# PROPOSED CHANGE NOTICE

2445-12

**RE:** AURORA FOOD STORE  
 2000 ANAQUOD ROAD  
 REGINA, SK  
 Commission No. 2445

**RE:** Exterior Signage

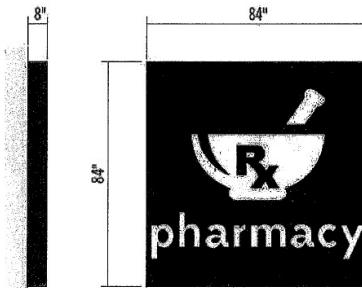
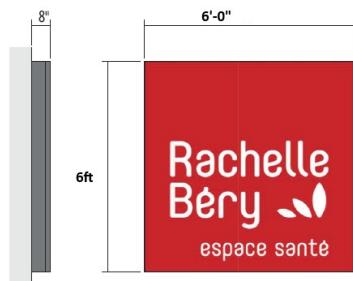
- .2 Provide fifteen (15) knife plates and three (3) horizontal HSS at front entrance signage, Located behind perforated aluminum backer panel.

**New Illuminated Fascia Sign Box | Rachelle Bery**

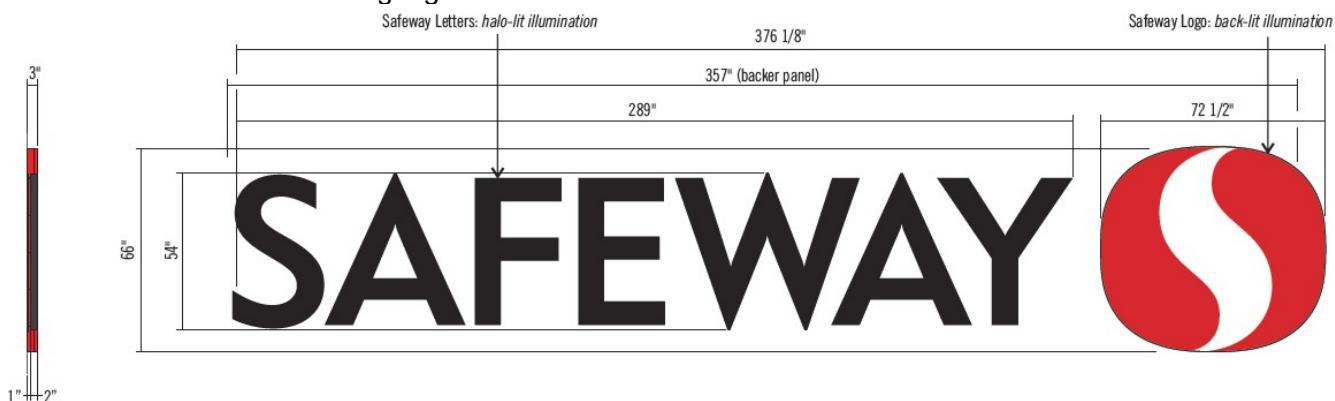
- .5 Provide 6'-0" x 6'-0" Rachelle Bery sign and 6'-0" x 6'-0" Pharmacy sign.  
 Underside of signage to be installed at 114'-10".

- Aluminum constructed sign box to be painted Alpolic Anthracite Grey 92459
- Aluminum constructed flex face tension retainer (frameless cover) to be painted Alpolic Anthracite Grey 92459
- White flex face with translucent vinyl applied to 1st surface
- White LED illumination
- Signage to be mounted flush to exterior wall

- Dark Red 3M 3630-3630-73

**New Illuminated Halo-lit Channel Letters | Safeway letters**

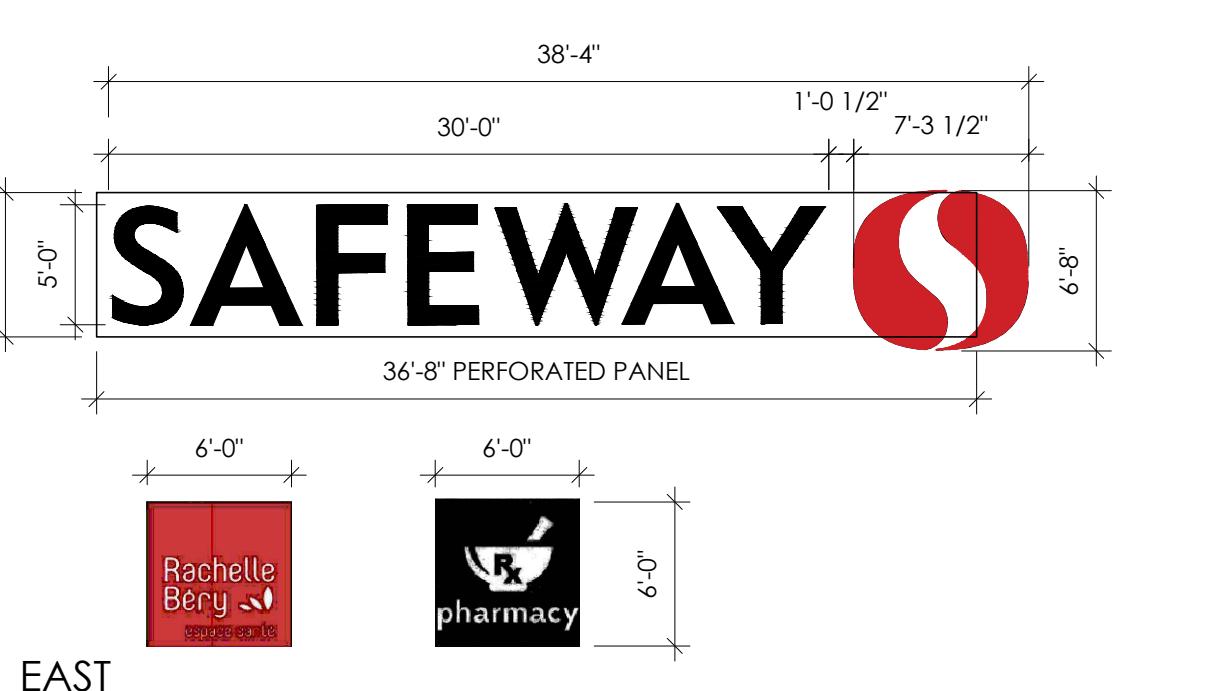
- .6 Provide SAFEWAY signage c/w logo at West and North elevations.  
 Underside of signage to be installed at 115'-8".

- Router cut aluminum faces with 2" returns to be painted black
- White LED illumination (halo-lit)
- Letters to be mounted 1" off exterior wall

SHEET TITLE:  
EXTERIOR ELEVATIONS  
COMMISSION NUMBER:  
2445  
SHEET NUMBER:  
A4.0  
FILE: 2445-A4.0 - EXTERIOR ELEVATIONS.DWG

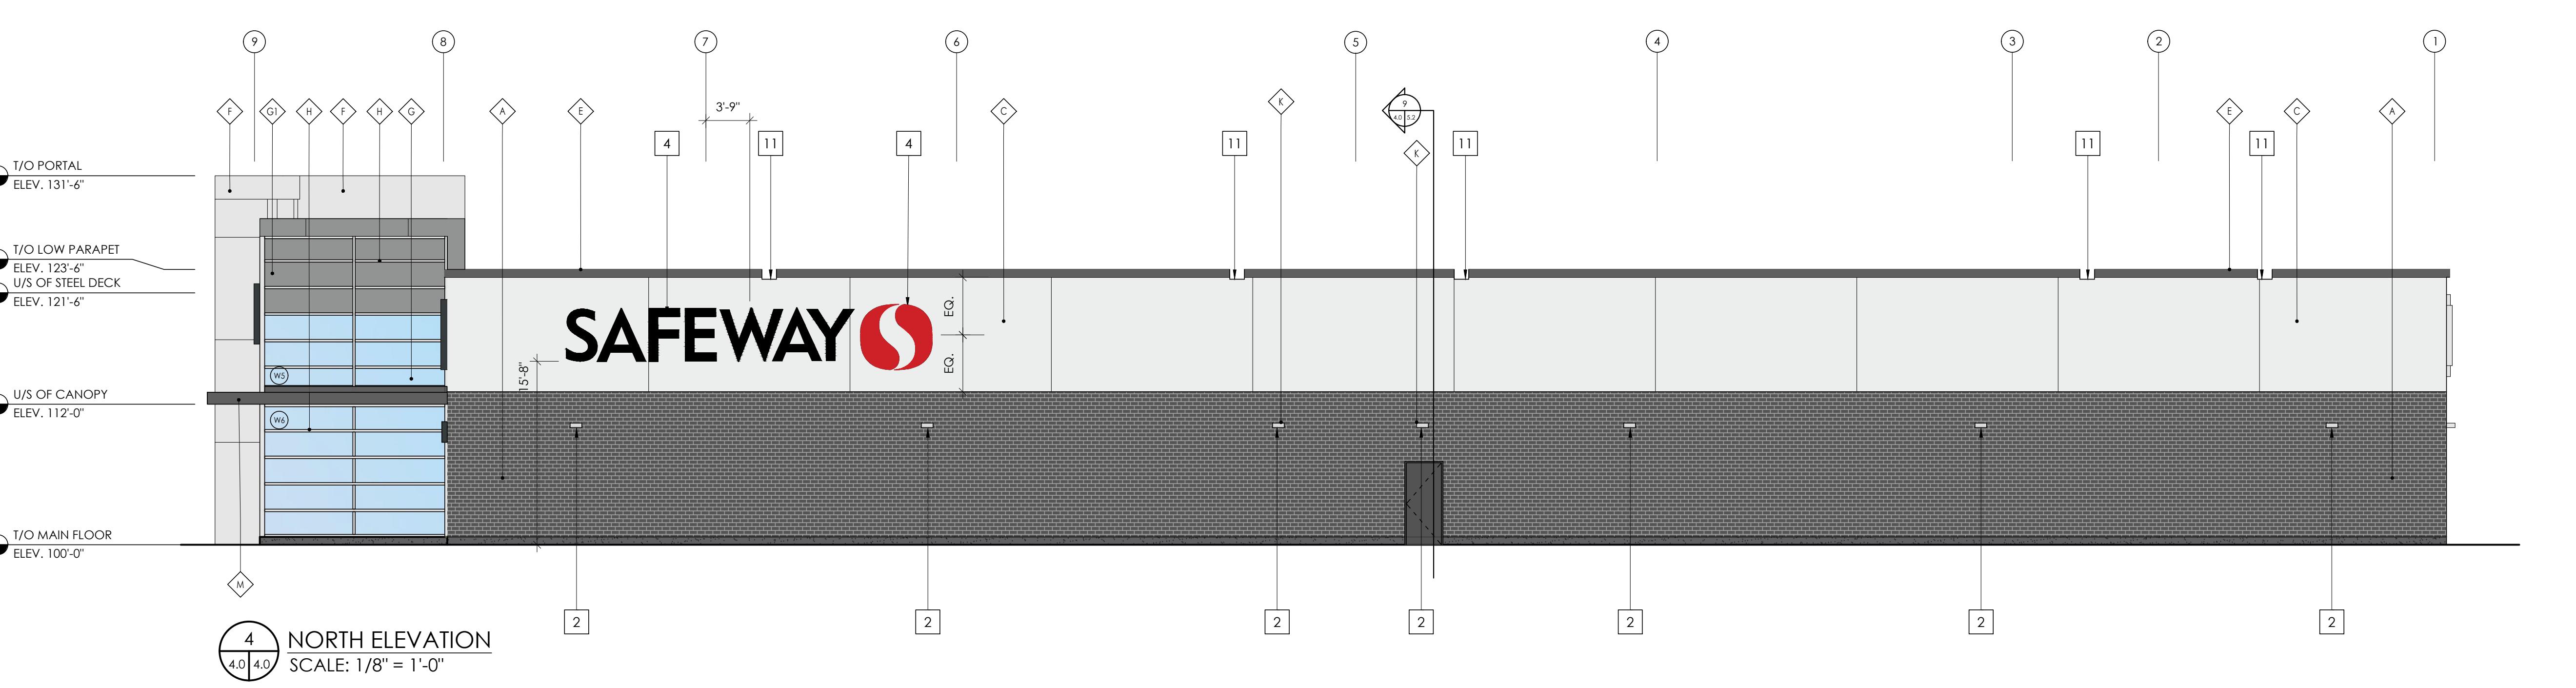
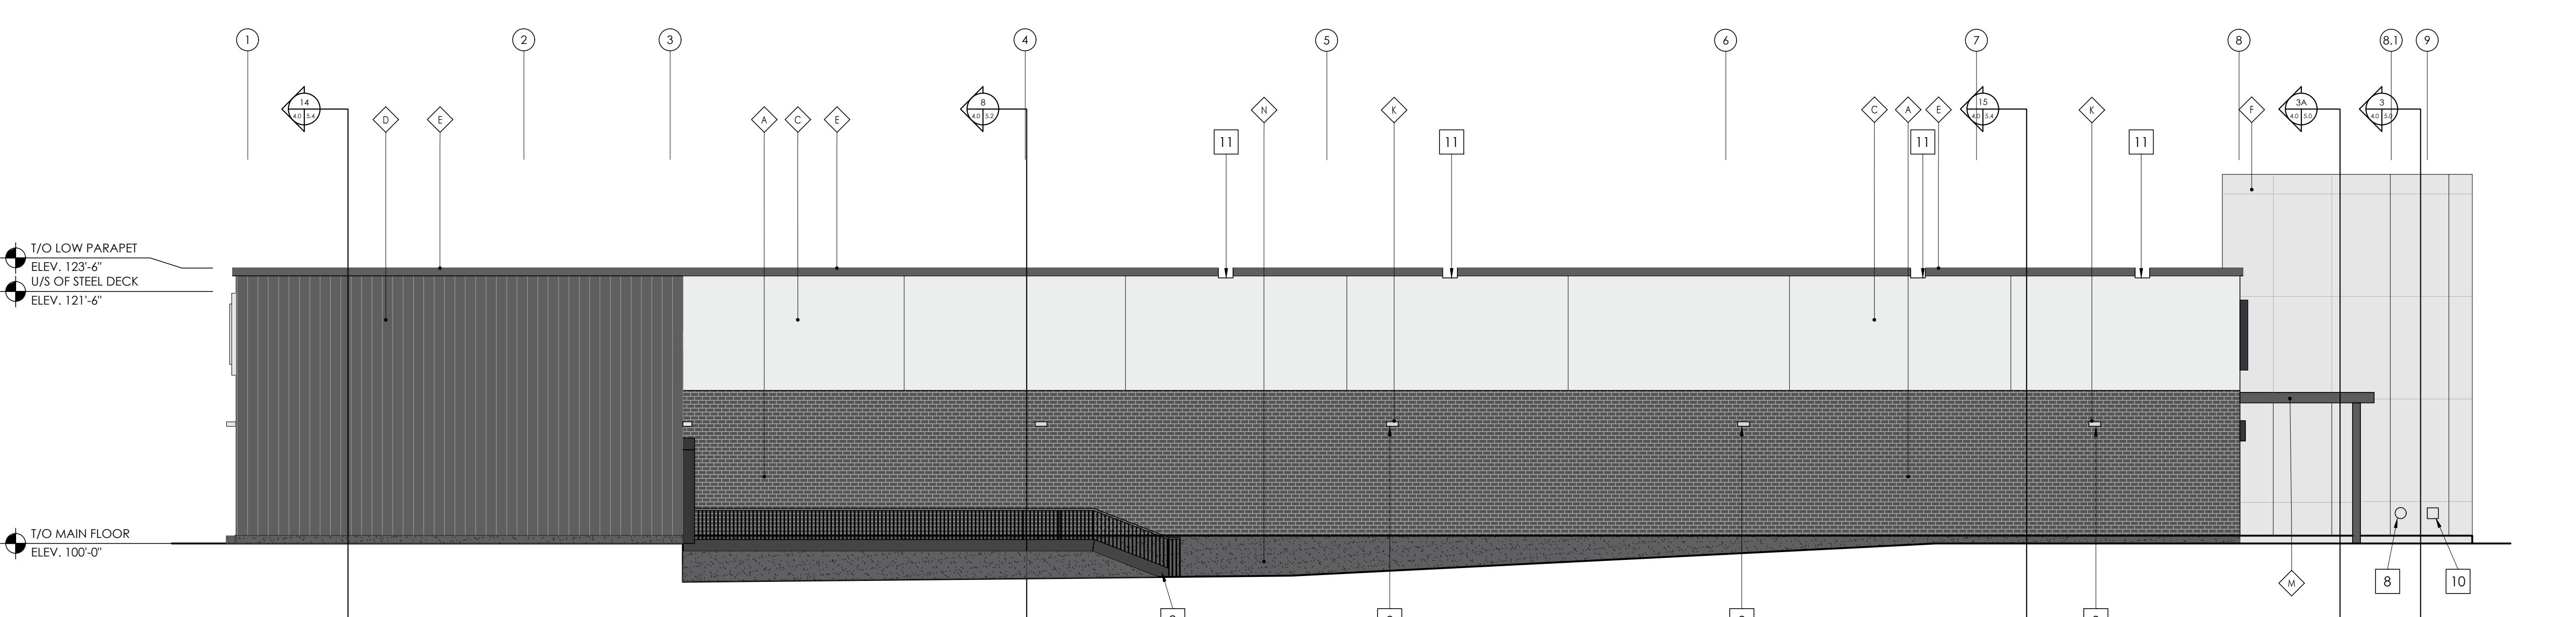
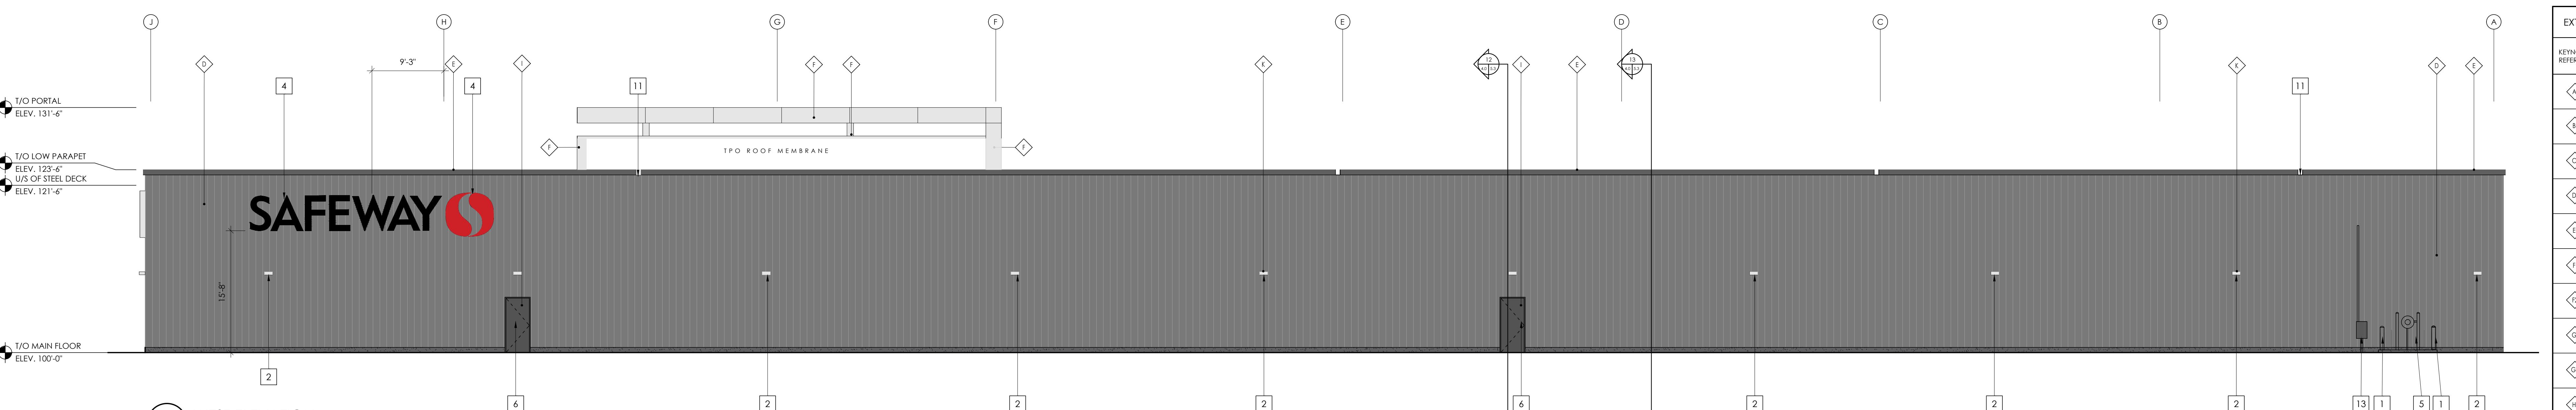
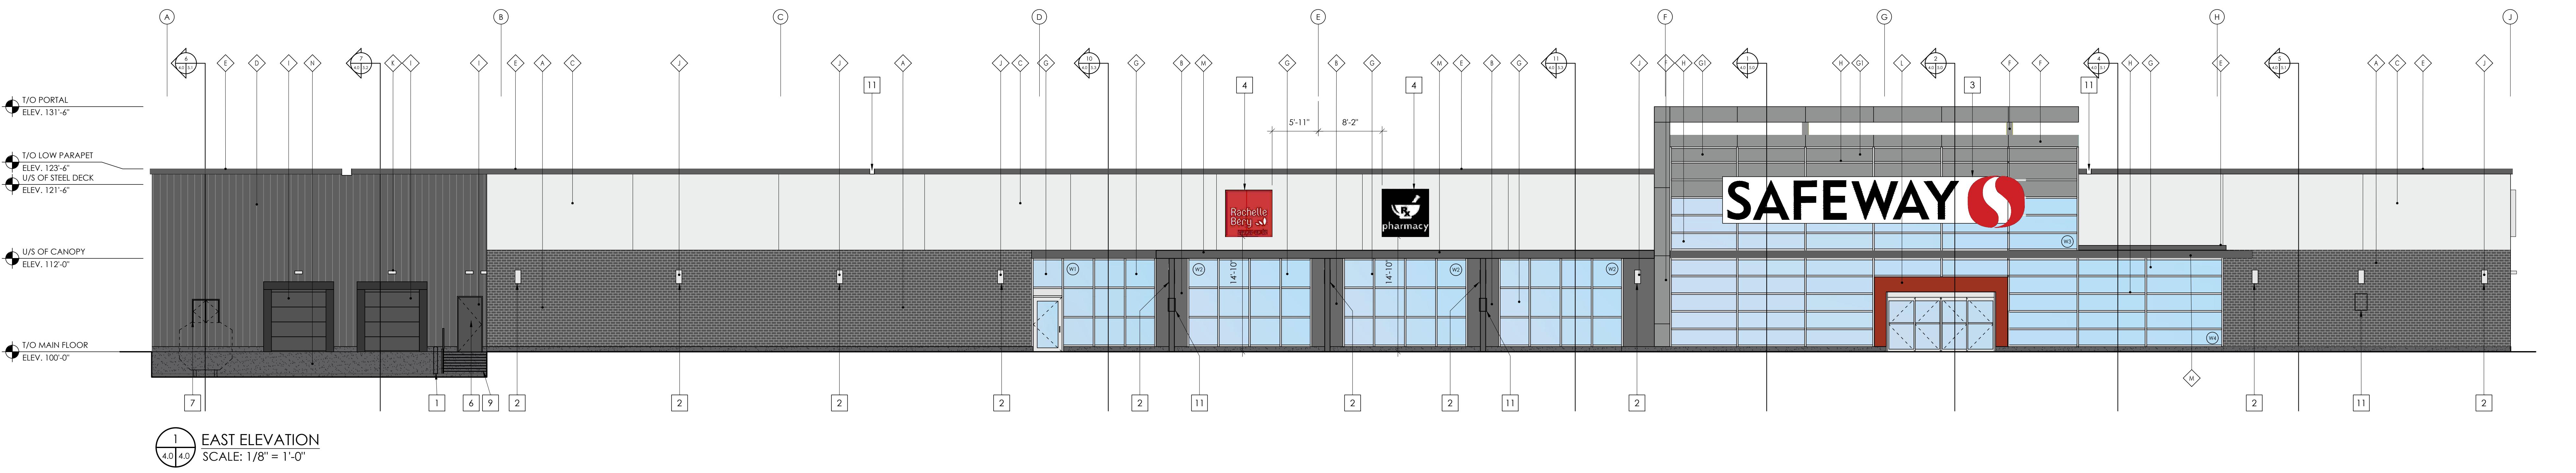
- .7 Delete circular sign from front/East elevation.  
 .8 Refer to attached exterior elevations (1 page).
